TESTIMONY OF HARI NARAIN SINGH CONCERNING
STABILITY OF THE DIKES ADJACENT
TO THE EMERGENCY COOLING WATER RESERVOIR

SUBJECT: REQUEST FOR ADDITIONAL INFORMATION REGARDING PLANT FILL

SUBJECT: Interagency Agreement No. NRC-03-79-167, Task No. 1 - Midland Plant
Units 1 and 2, Subtask No. 1 - Letter Report

SUBJECT: Interagency Agreement No. NRC-03-79-167, Task No. 1 - Midland Plant,
Unit 1 and 2, Subtask No. 3 - Review Comments on Amendment 85

Figure 37

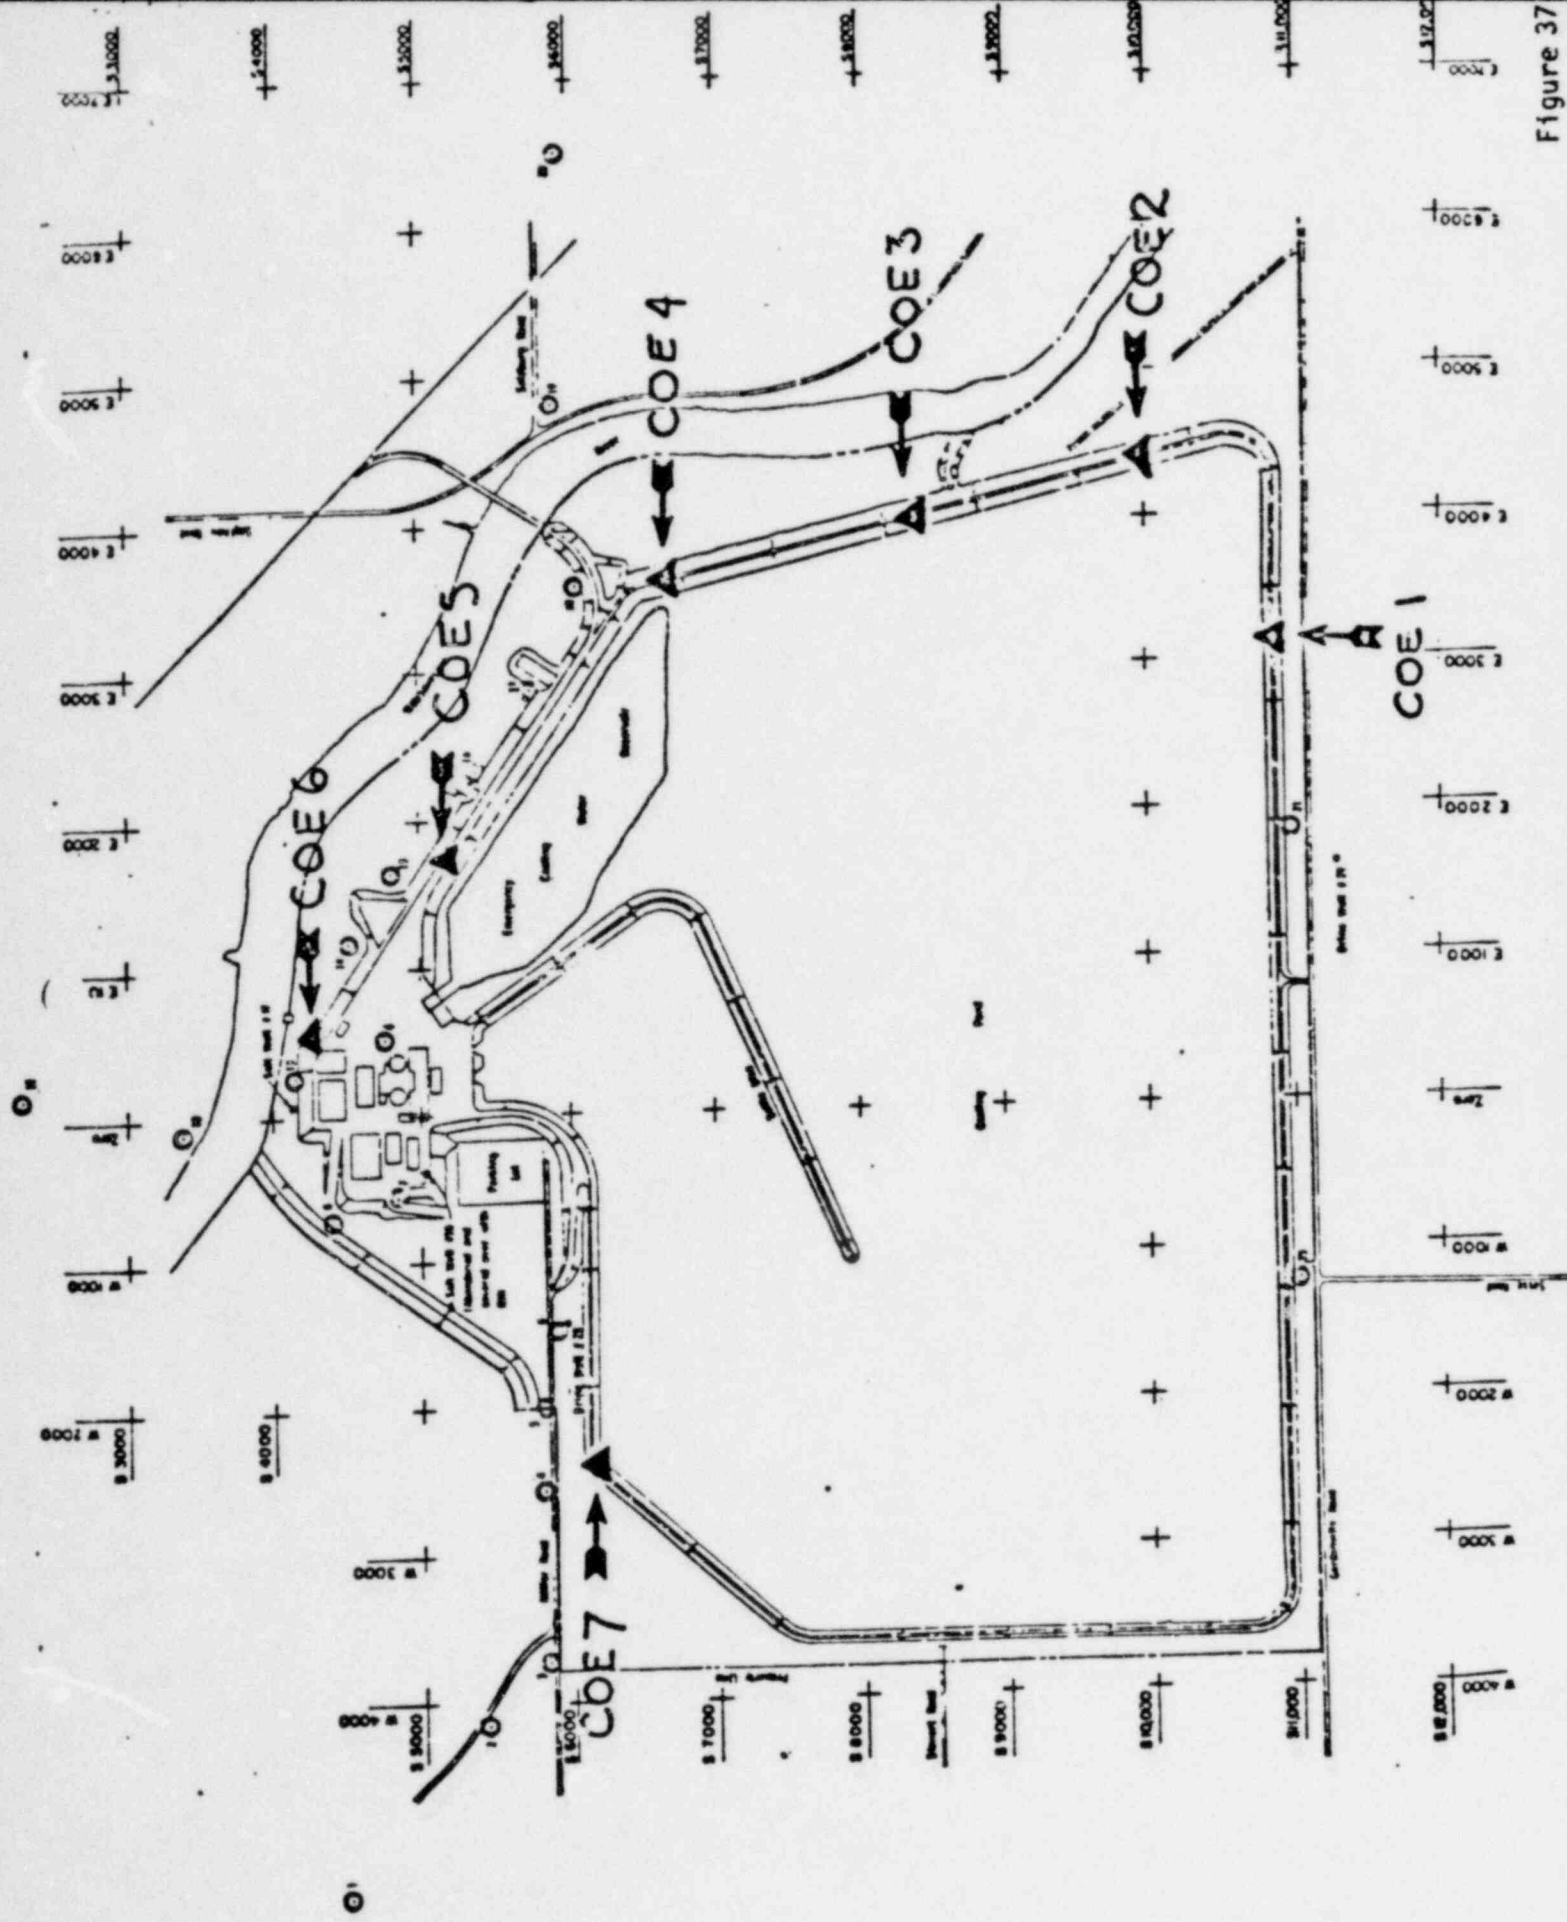
37. (RSP) Your position in previous responses to Requests 5 and 35 not to complete additional explorations, sampling and laboratory testing following the preload program continues to be unacceptable. We require that you complete as a minimum, the exploration and testing program indicated by Table 37-1.
38. Discuss the foundation design for any seismic safety-related piping and conduit connected to or located under the Radwaste Building and Turbine Building where piping and conduit have been placed on plant fill.

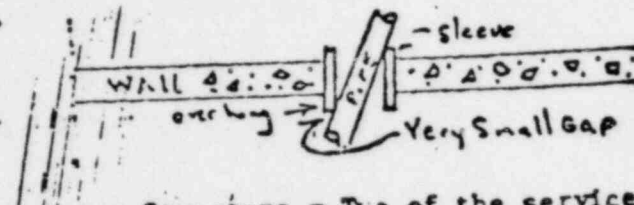
(c) The response to Question 17 of "Responses to NRC Requests Regarding Plant Fill" states that "there is no reason to believe that the stresses in Seismic Category I piping systems will ever approach the Code allowable." We question the above statement based on the following:

Profile 26" - OHBC-54 on Fig. 19-1 shows a sudden drop of approx. 0.2 feet within a distance of only 20 feet. Using the procedure on p. 17-2,

$$\sigma_b = 30000 \left(\frac{26}{2} \right) \left[\frac{8(0.2)(12)}{(20 \times 12)^2} \right] = 130.0 \text{ KSI}$$

Figure 1

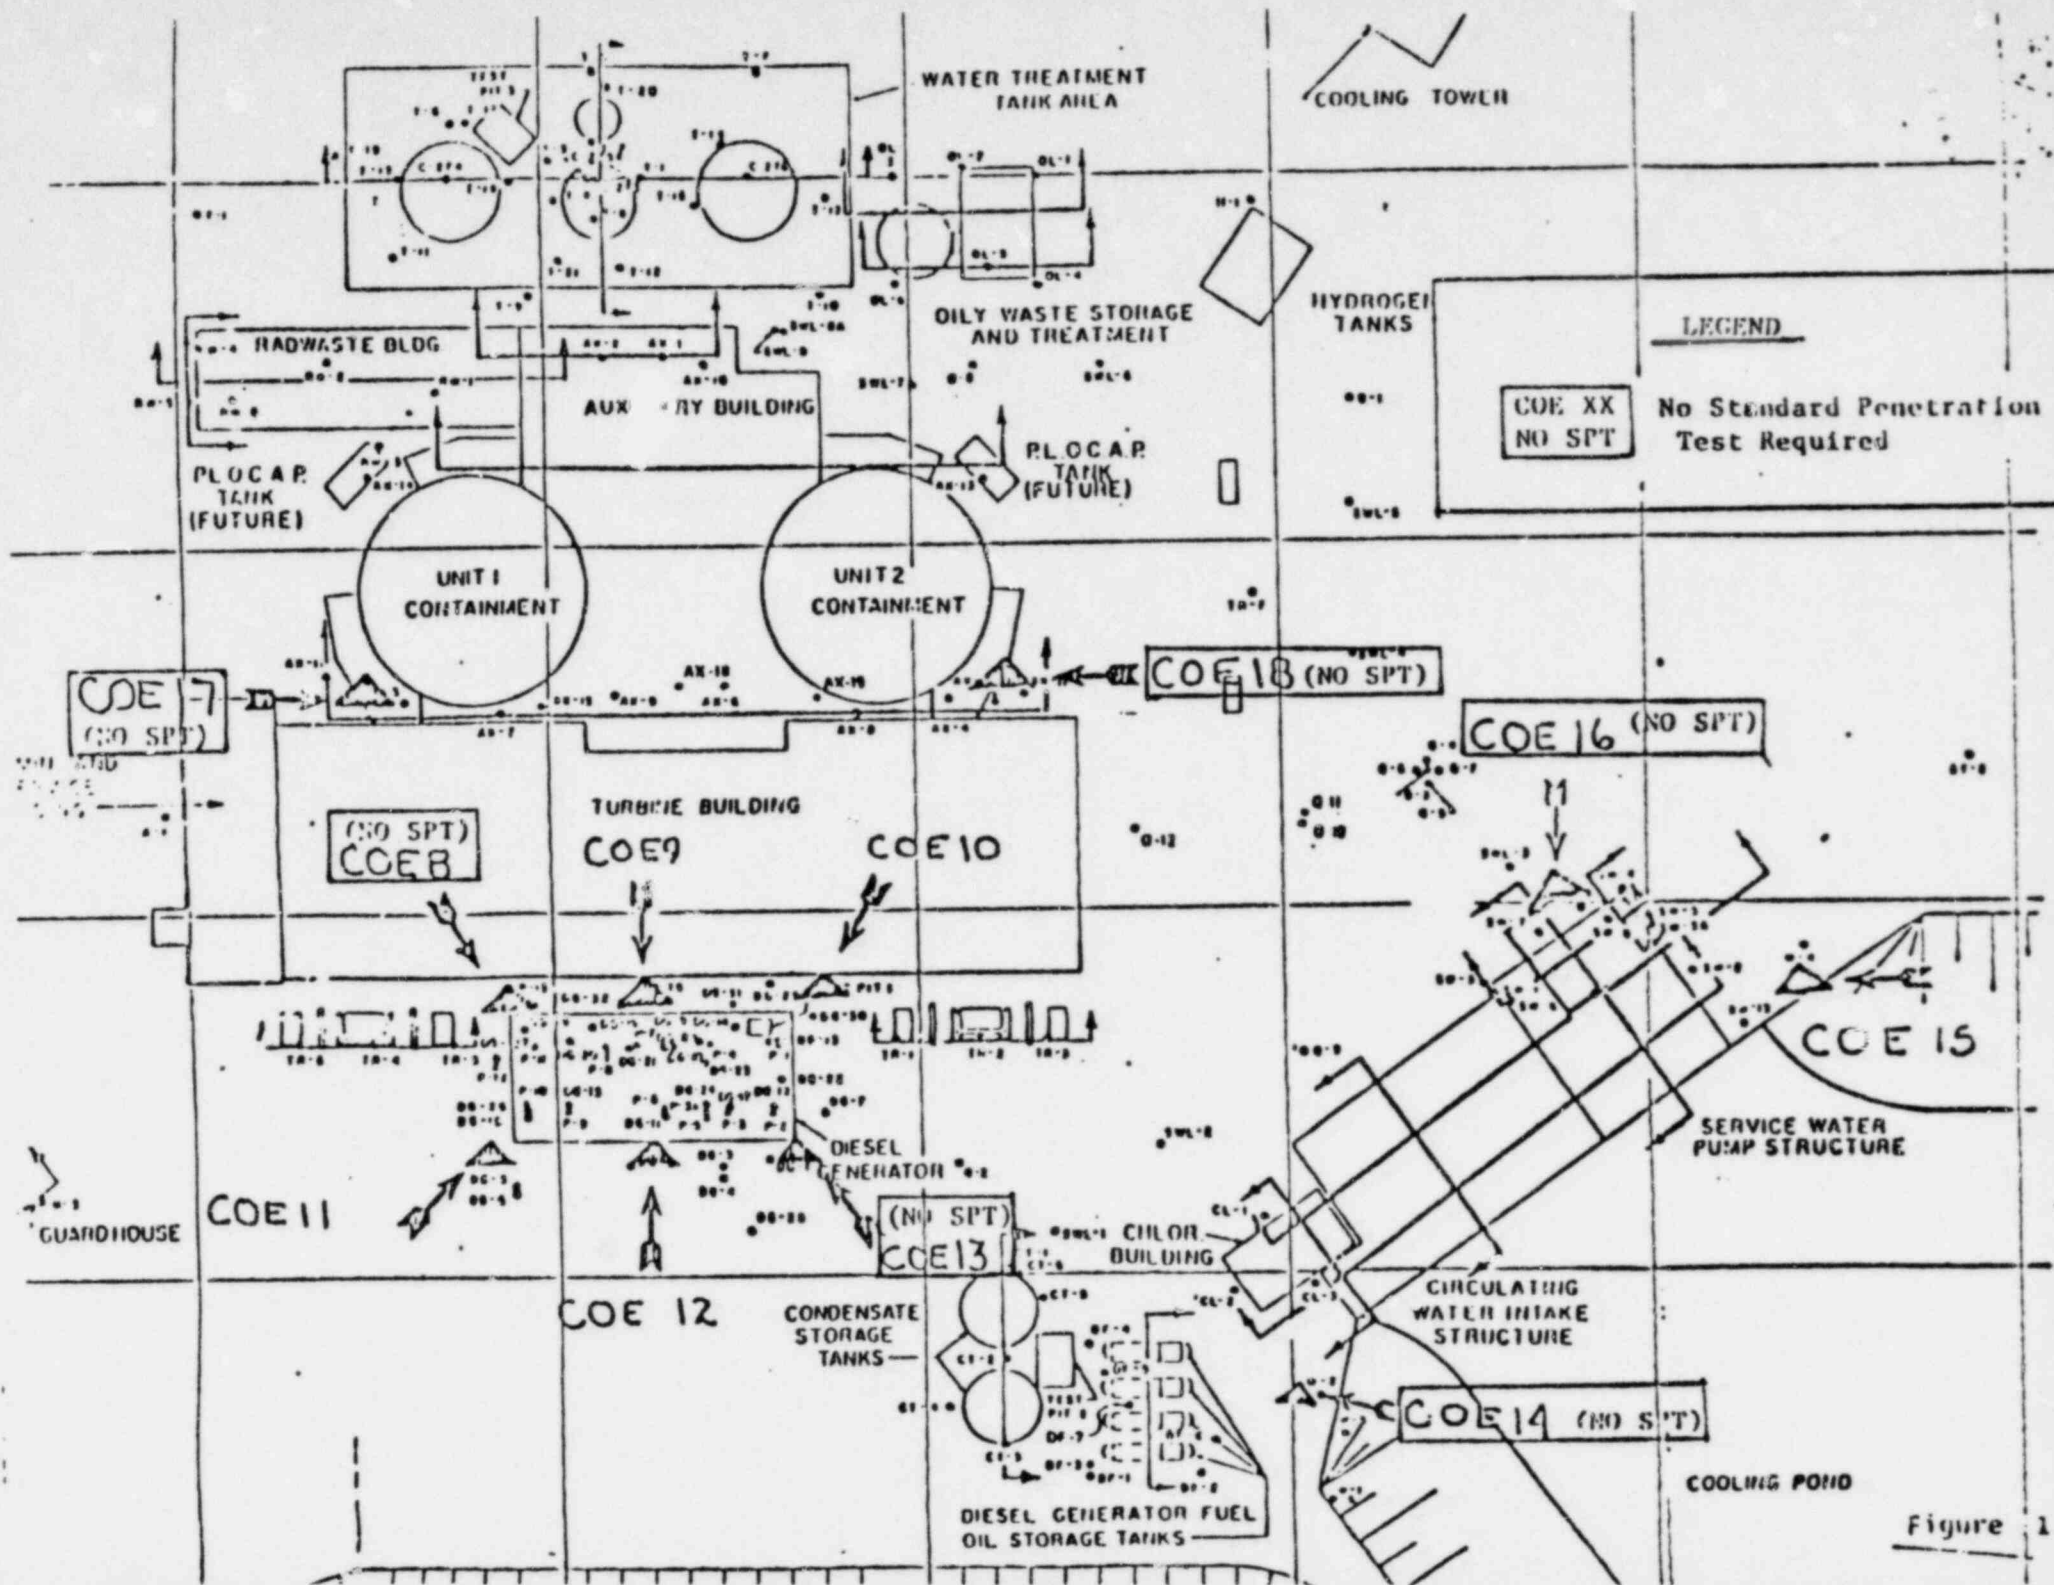
Details of this relaxation are further described in the enclosed letter of December 2, 1980 by Mr. P. McCallister of the U. S. Army Corps of Engineers, our geotechnical consultant. Mr. McCallister's letter includes a revised sketch (Figure 1) showing all the borings in the plant fill area and noting the six borings from which the SPT's have been eliminated. Mr. McCallister's letter also includes a revised sketch (Figure 2) showing the relocated boring locations on the cooling pond dikes. Figure 2 shows the new locations for borings COE-1, COE-2 and COE-3 (previously located in the south and east dikes), and boring COE-7 (previously located in the northwest area). We further endorse Mr. McCallister's comments regarding selection of undisturbed sample locations and his requests that the guidance of Regulatory Guides 1.132, "Site Investigation for Foundation of Nuclear Power Plants," and Regulatory Guides 1.138, "Laboratory Investigation of Soils for Engineering Analysis and Design of Nuclear Power Plant" be used as appropriate.

We have reviewed the NRC letter, and concur with the decision reached. The six (6) boring locations, from which requirements of the Standard Penetration Tests (SPT) have been relaxed were provided in our letter of 30 September 1980. We are inclosing a new map (Figure 1) showing all the borings in the plant fill area with special identification of the six (6) borings from which the SPT's have been eliminated. We are also inclosing a map (Figure 2) showing the relocated boring locations on the cooling pond dikes. In our opinion, relocations of the three borings (COE-1, COE-2 and COE-3) from the south and east dikes and one boring (COE-7) from the northwest area to the emergency cooling pond dikes are advisable. Data from these four relocated borings will help evaluate the stability of the dike around the Category I Emergency Cooling Pond (baffle dike and main dike). This will also help evaluate any potential impact on Category I discharge pipes which are located along either side of the emergency cooling pond and ultimately enter the reservoir at the south end.
